**IEEE P802.11****Wireless Access Method and Physical Layer Specification**

**PCF State Machine Definition**

**Type:** Provides missing information. The PCF is defined in section 5.3 of document 93-20b2, but the MAC state machines in section 5.7 do not include PCF operations. These state machines implement PCF functionality as specified in the current draft.

**Objective:** Inclusion of the portions of this document relevant to PCF and CF-Async state machine definition into the Draft Standard.

Figure 1: Modified Receive State Machine

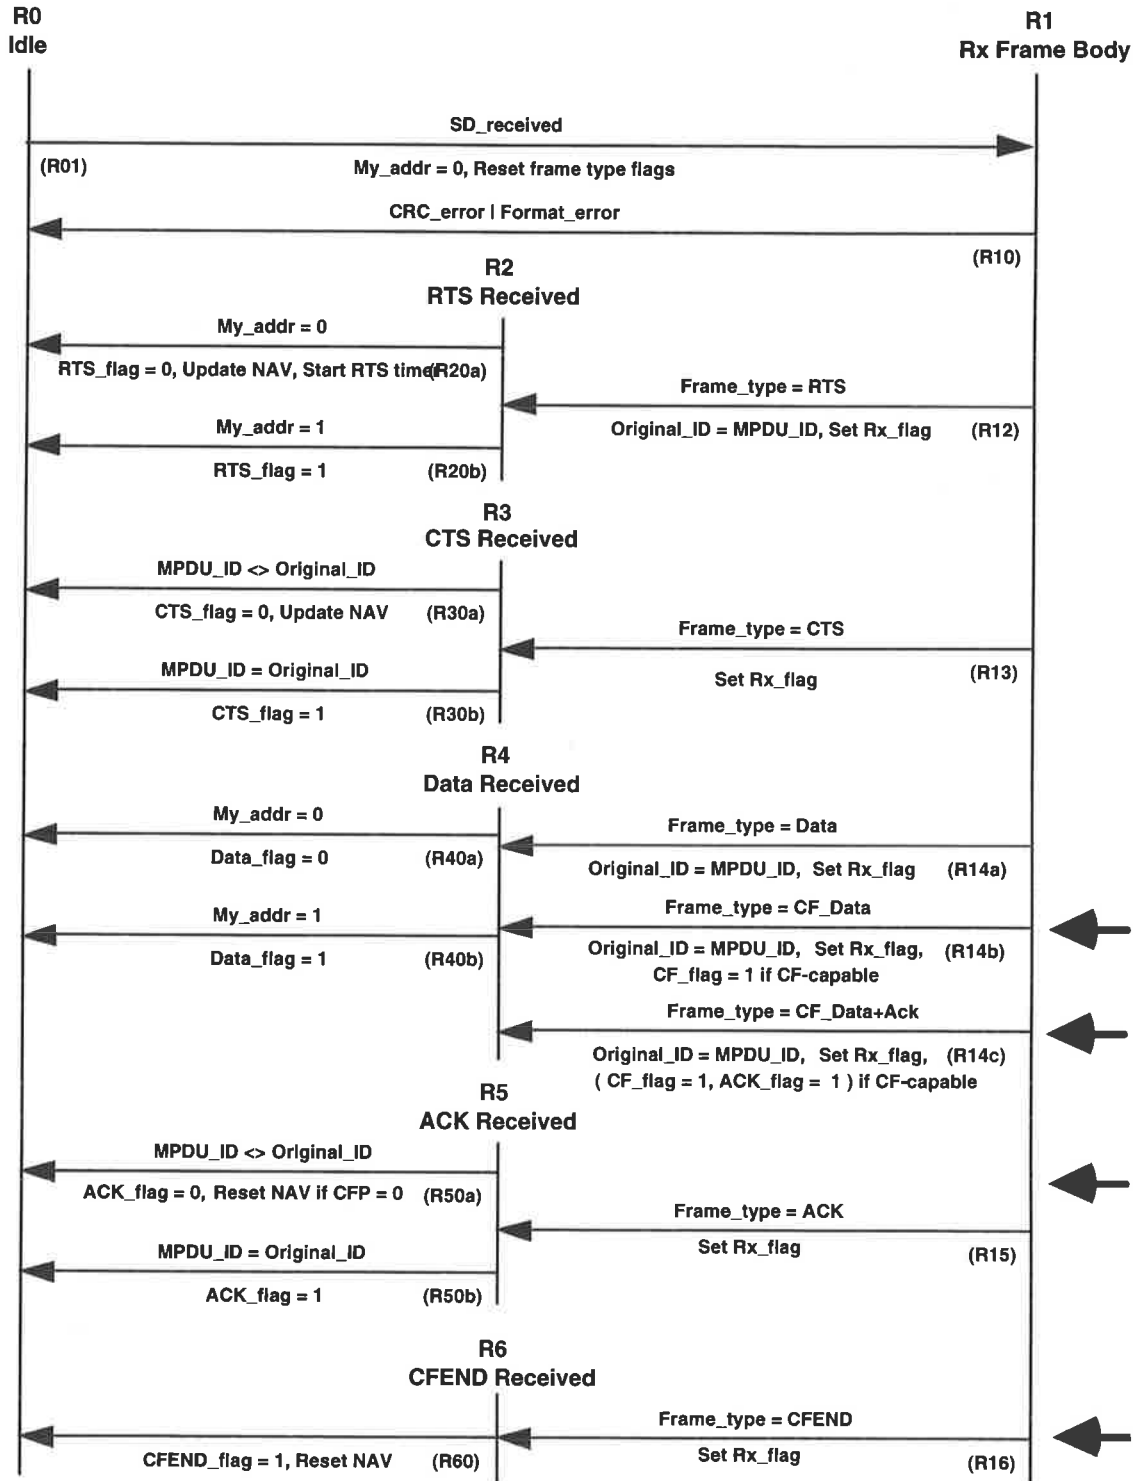
Figure 1 is a copy of the receive state machine diagram from document 93-20b2, with the necessary modifications. The new state transitions are marked with large black arrows in the right margin, while the modified transitions are marked with gray arrows. The remainder of the receive state machine is unchanged. The notes below apply to the added and modified portions of the diagram.

**[NEW] R14b, Received\_CF\_Data:** When the frame is valid and the frame type is CF\_Data, this transition shall be taken. Rx\_flag shall be set, and Original\_ID shall be set to MPDU\_ID. If the station is CF-capable, the CF\_flag shall be set. This setting of the CF\_flag must occur prior to address validation because the control state machine, at CF-capable stations, must know of the receipt of CF frames independently of whether those frames are addressed to this station.

**[NEW] R14c, Received\_CF\_Data+Ack:** When the frame is valid and the frame type is CF\_Data+Ack, this transition shall be taken. Rx\_flag shall be set, and Original\_ID shall be set to MPDU\_ID. If the station is CF-capable, the CF\_flag and ACK\_flag shall be set. This setting of the CF\_flag and ACK\_flag must occur prior to address validation because the acknowledgment may apply to a frame sent by this station when the addressee of the subsequent CF\_Data+Ack frame is the next station on the PCF's polling list.

**R50a, Other\_ACK:** This transition shall be taken when the ACK receipt actions are complete and the MPDU\_ID is not equal to the Original\_ID. The ACK\_flag shall be reset. The NAV shall be updated to indicate that the network is now free unless CFP=1 to indicate that the contention-free period is in progress, in which case the NAV is not modified.

**State R6, CFEND Received:** This state shall be entered when a valid CFEND frame is received.

**R60, CFEND\_complete:** This transition shall be taken when the CFEND receipt actions are complete. The NAV shall be reset, which results in the occurrence of state transition C00f by the control state machine, to indicate the end of the contention-free period. The CFEND\_flag shall be set.

Figure 2: Modified Control State Machine

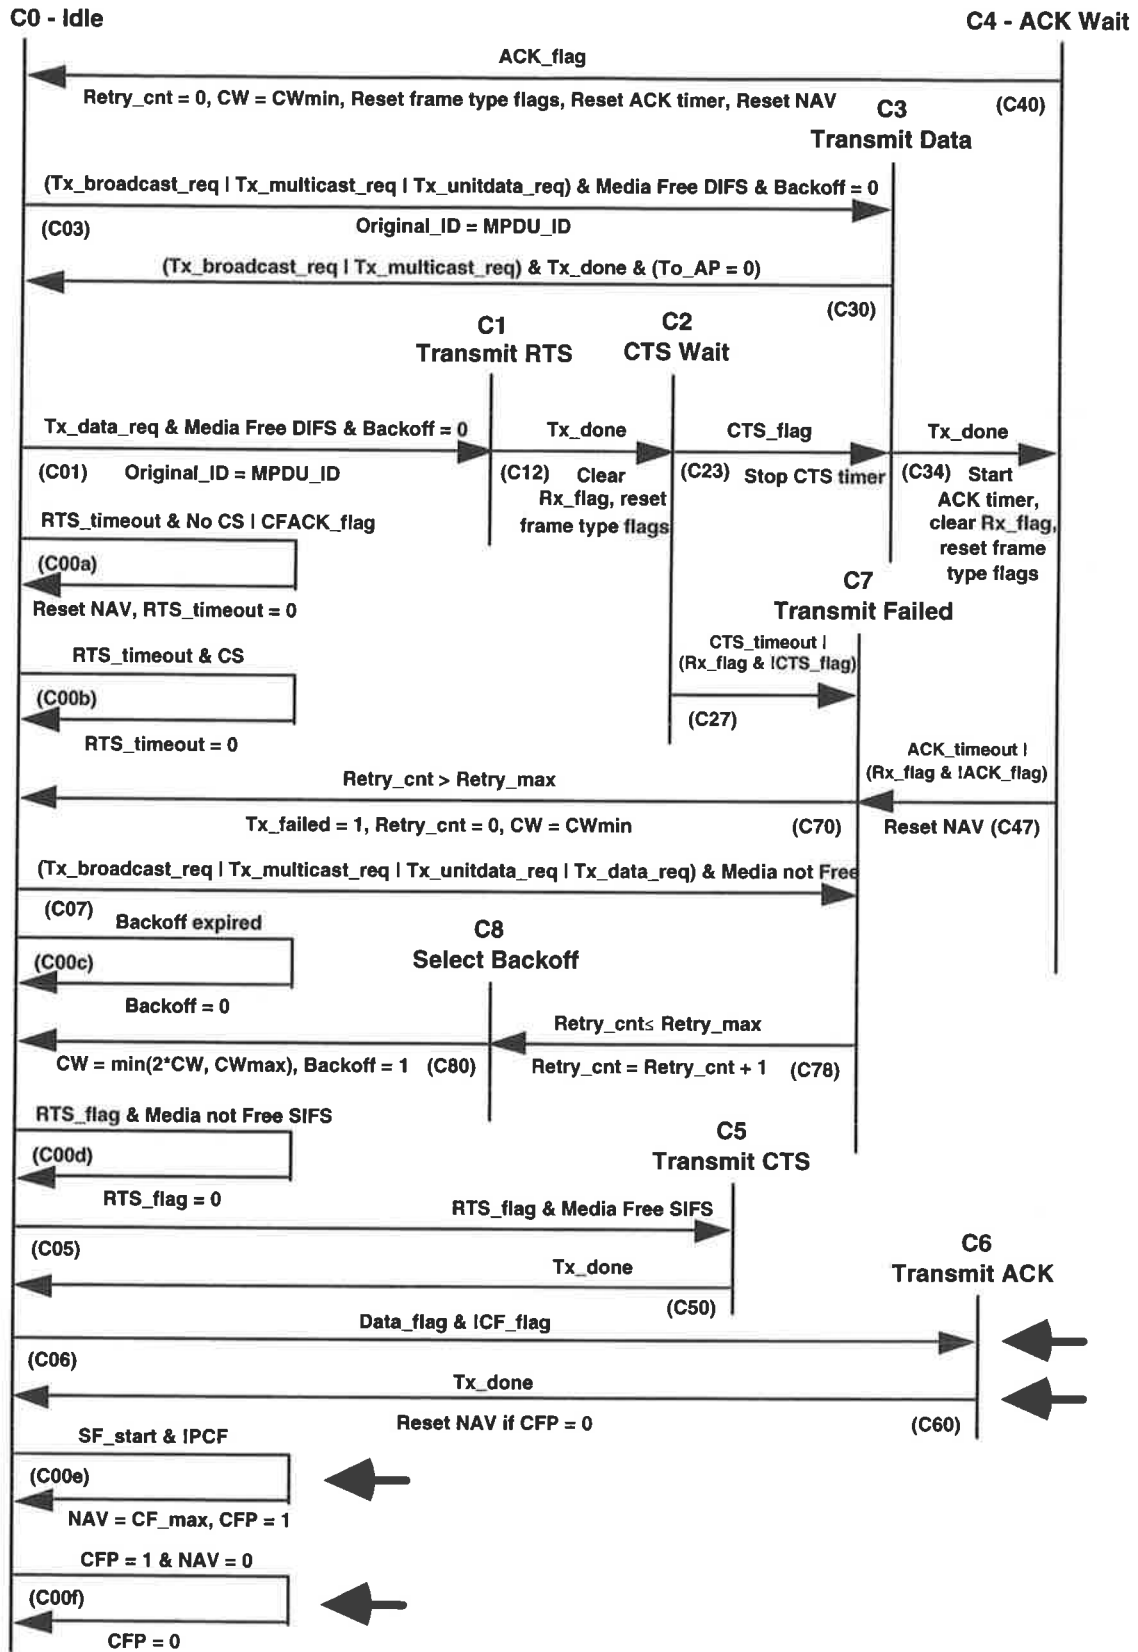
Figure 2 is a copy of the control state machine diagram from document 93-20b2, with the necessary modifications. The new state transitions are marked with large black arrows to their right, while the modified transition is marked with a gray arrow. The remainder of the control state machine is unchanged. The notes below apply to the added and modified portions of the diagram. These modifications are needed at all stations, whether or not they are CF-capable. These modifications assume the existence of a new timer that shall be set to the Superframe duration and synchronized to indicate the expected starting time of each Superframe.

**[NEW] C00e, Start\_CF\_period:** This transition shall be taken when the Superframe timer indicates the expected start of the next Superframe and this station is not providing the PCF for the BSS. (The “!PCF” condition is true both for stations that are not capable of providing the PCF, as well as those that are capable of providing the PCF but are not presently doing so.) The NAV shall be set to the maximum contention-free period length, and the flag CFP shall be set =1 to indicate that the contention-free period is (expected to be) in progress.

**[NEW] C00f, End\_CF\_period:** This transition shall be taken when the NAV has counted to zero (or been reset) while the contention-free period is (expected to be) in progress, as indicated by CFP = 1. CFP shall be cleared to =0 to indicate the end of the contention-free period.

**C06, Send\_ACK:** This transition shall be taken when a valid asynchronous data frame addressed to this station, or CF Data or CF Data+Ack frame addressed to this station (at a non-CF-capable station), is received.

**C60, ACK\_complete:** This transition shall be taken when the transmission of the ACK frame is complete. The NAV shall be reset if the contention-free period is not in progress, indicated by CFP = 0.
